elm creek Watershed Management Commission

Subject: Review Packet to Discuss ECWMC Rule F: Floodplain Alteration for the Chankahda Trail Phase 2 Reconstruction Project.

**RE: *Elm Creek Watershed Management Commission - Project Review # 2023-01
Chankahda Trail Reconstruction – Phase 2; Rule F: Floodplain Alteration Compensatory
Storage Requirements***

**SUBJECT: ELM CREEK WATERSHED MANAGEMENT COMMISSION - PROJECT REVIEW # 2023-01
CHANKAHDA TRAIL RECONSTRUCTION – PHASE 2
RESPONSE TO FINAL COMMENTS**

K:\TWC_Civil\City\PLYMOUTH\CR 47_PHASE 2_FINAL DESIGN\CAD\Plan Sheets\Exhibits\CR47-PH2 -100 Year Floodplain Grading-PeonyAlt.dwg June 29, 2023 - 9:17am

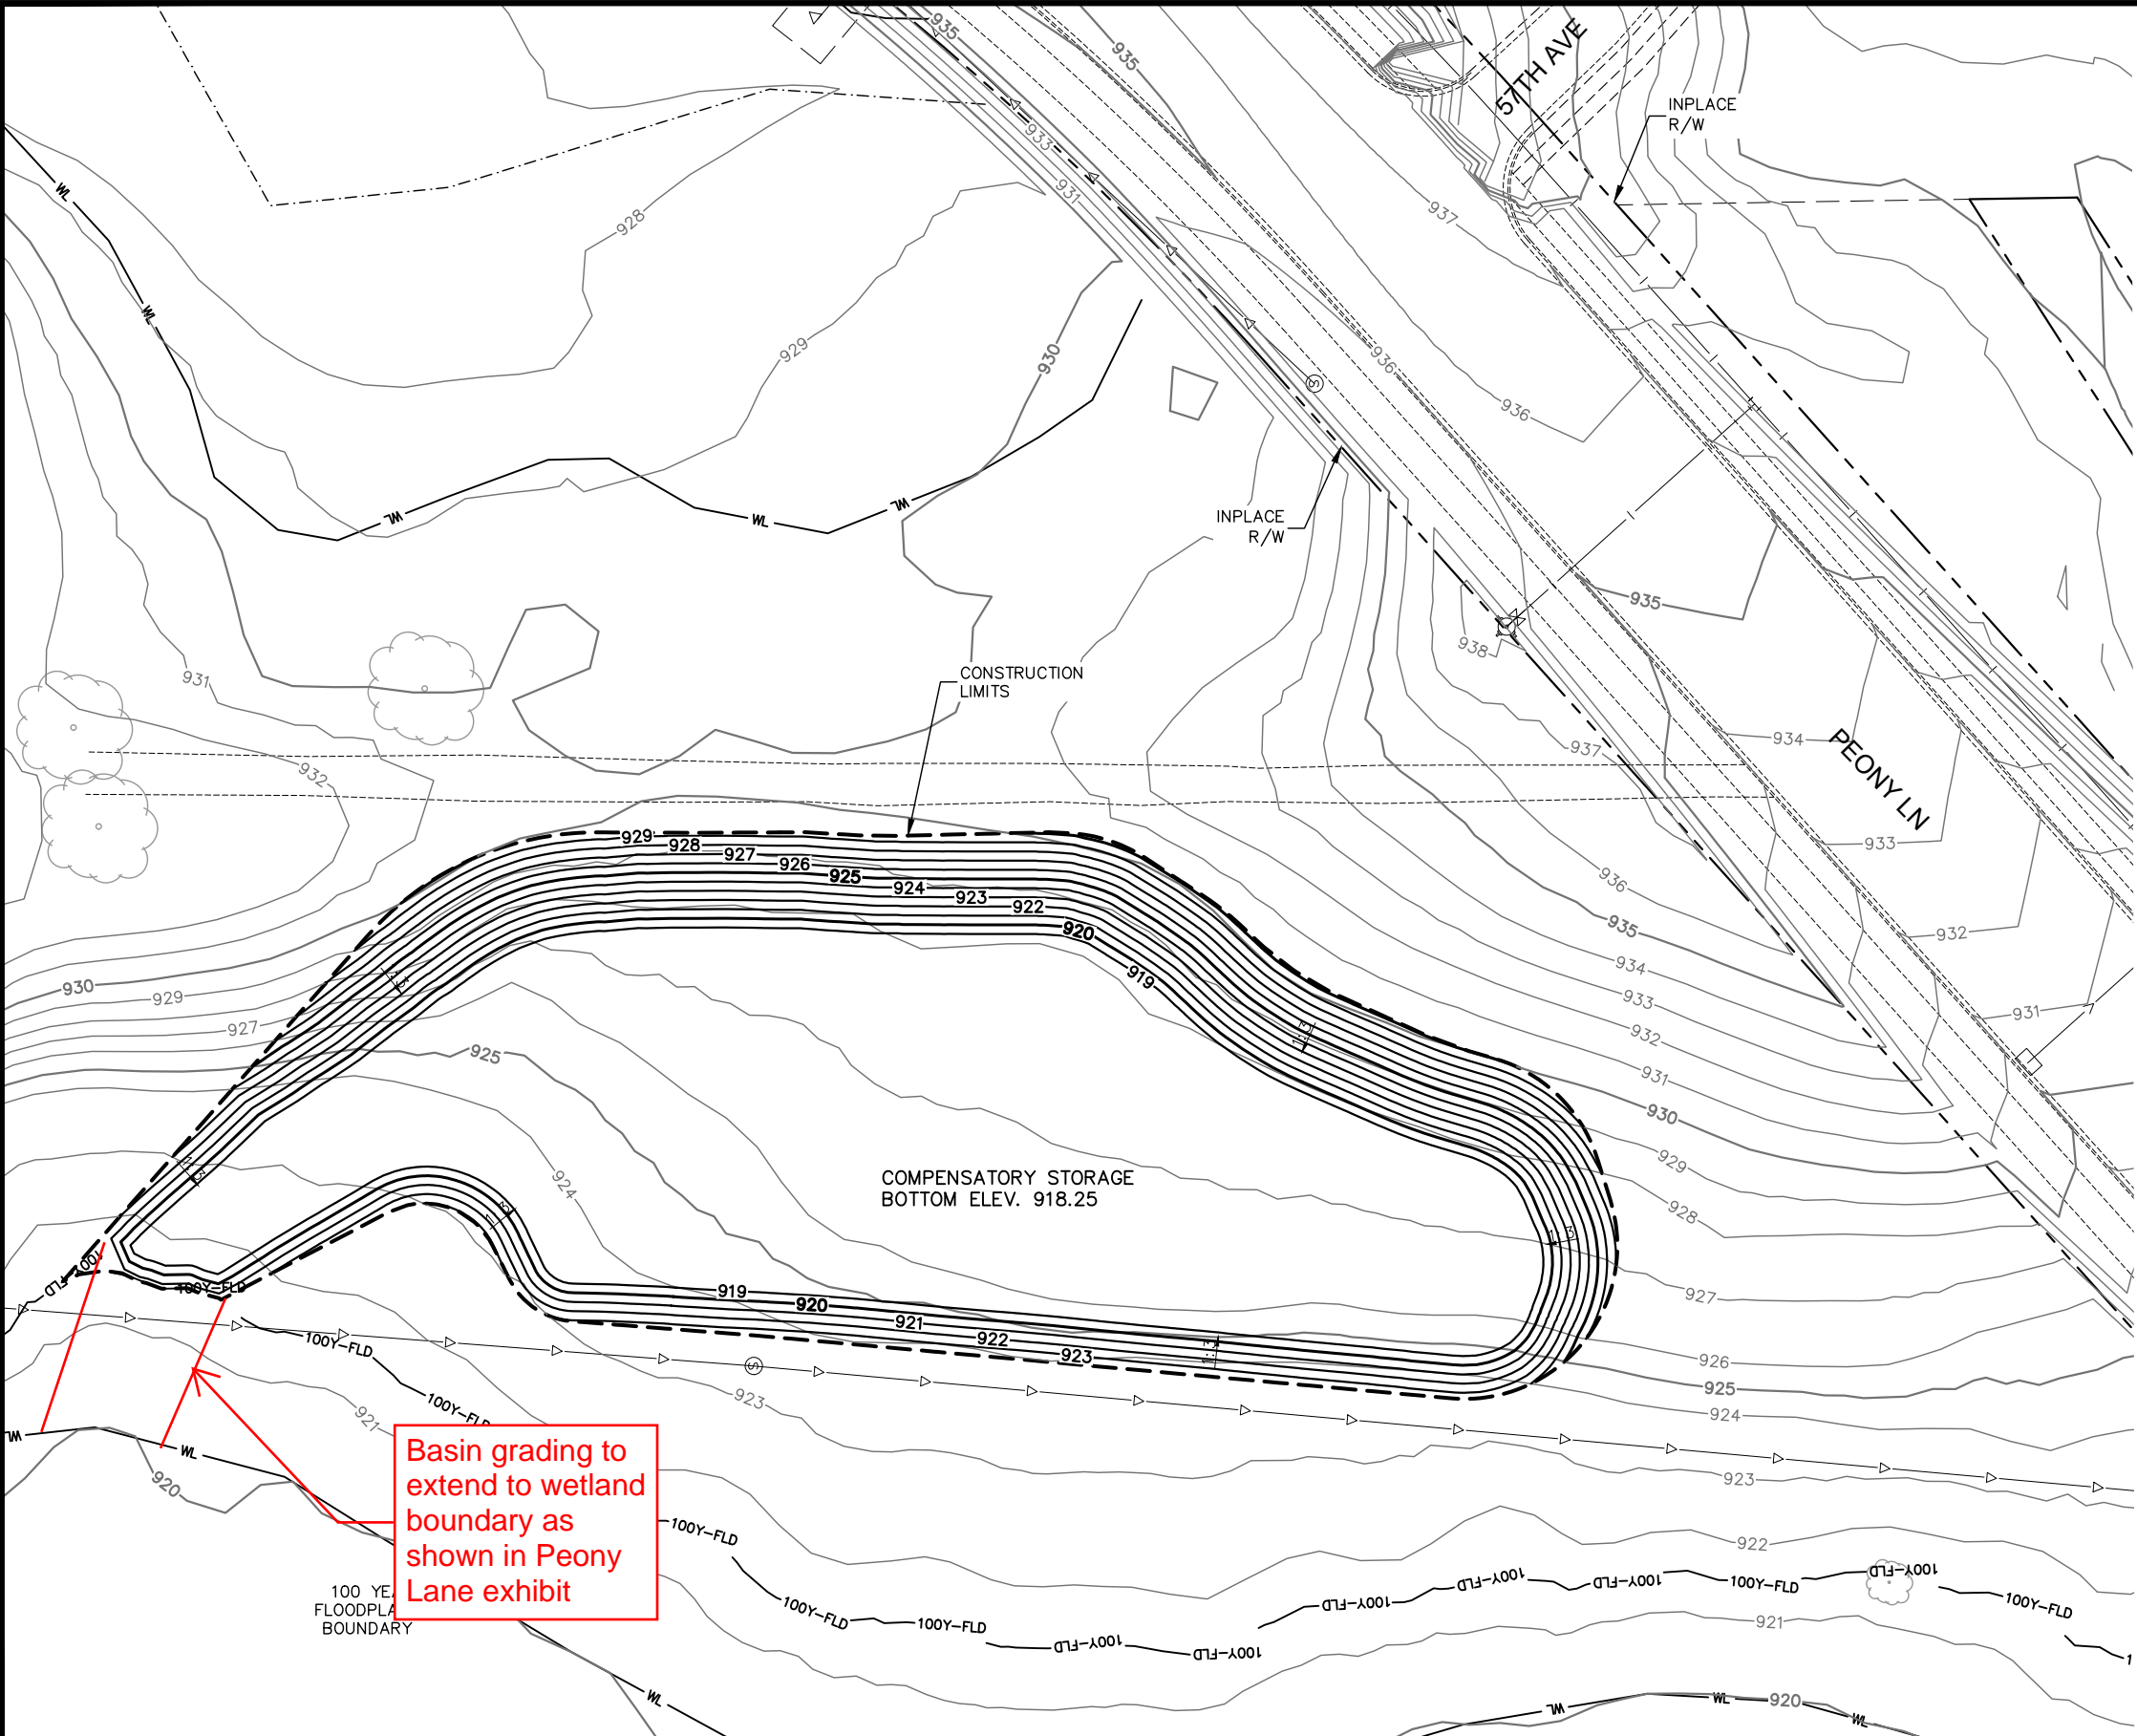
During the meeting with ECWMC on 3/27/23, the watershed stated concern regarding the current basin bottom of 918.25. The watershed stated that the expected groundwater would be around the 920 elevation and that the basin would be continually full of water below 920. The watershed requested the City provide proof of groundwater levels to approve the current design. The City hired Braun Intertec to install a piezometer to measure the groundwater elevation in April 2023. Measurements indicated the current groundwater elevation was much higher than anticipated at approximately 920.

The original compensatory storage grading does not provide a hydraulic connection to the floodplain, as there is a berm at the 100-year HWL, so surface water elevations would have to exceed the 100-year HWL to utilize the compensatory storage.

The original compensatory storage grading also is not separated from groundwater, based on the piezometer readings you provided from Braun. In my talks with Jim Kujawa, the Commission has not historically allowed compensatory storage to be provided below the normal water level or groundwater levels of basins, as these areas are not floodable and will cause a 'net decrease in flood storage capacity below the projected 1% (100-year) critical flood elevation'. How ECWMC Staff have interpreted the compensatory storage, or 'floodable' area, is consistent with the National Flood Insurance Program (NFIP) definition of compensatory storage which states, "The developer is required to offset new fill put in the floodplain by excavating an additional floodable area to replace the lost flood storage area."

After receiving the piezometer results, the basin was reevaluated to raise the basin bottom elevation to 920. The floodplain compensatory storage was now only counted between 920 and 921.5 per request by the watershed's engineer. In order to achieve the required 4,892 cubic yards of floodplain compensatory storage within that 1.5 feet, the basin footprint needed to expand significantly. The new basin requires 26,300 cubic yards of common excavation. The total cost for this work is approximately \$370,000.

The City believes that the original compensatory storage basin design meets the intent of ECWMC's Rule F by providing flood storage from 918.25 up to the 100-year floodplain elevation of 921.5. The redesigned basin with a bottom elevation of 920 creates an extremely large basin that almost doubles the cost of the original design, which is beyond what is reasonable to meet the floodplain compensatory storage requirements stated in the watershed's rules. In addition, the total floodplain storage south between Chankahda Trail and Peony Lane in the large wetland complex is approximately 290,287 cubic yards. The 4,892 cubic yards of fill and subsequent compensatory storage provided due to the project impacts is only 1.7% of the total floodplain storage in the south wetland complex. With this small of an impact to the total flood storage, there would be no negative flooding impacts and is negligible in the updated floodplain model. The City believes that the basin design meets Rule F and is requesting that the watershed consider approving the original basin design.

See Response #2 above. The compensatory storage area is hydraulically connected to the Elm Creek wetland to the east of the storage area through infiltration and groundwater.

This comment indicates that the ECWMC is requesting the 100-year compensatory storage basin take on flood water during smaller rainfall events and connect to the observed normal water level of the Elm Creek wetland complex to the east. This is not explicitly stated within Rule F and we would like ECWMC to confirm this request, as it goes above and beyond what is listed within Rule F.

The proposed compensatory storage area is designed to provide storage for fill placed within the 100-year floodplain boundary of Elm Creek due to project impacts associated with the culvert crossing of Elm Creek. We believe the designed compensatory storage area as revised, meets ECWMC's Rule F: Floodplain Alteration.
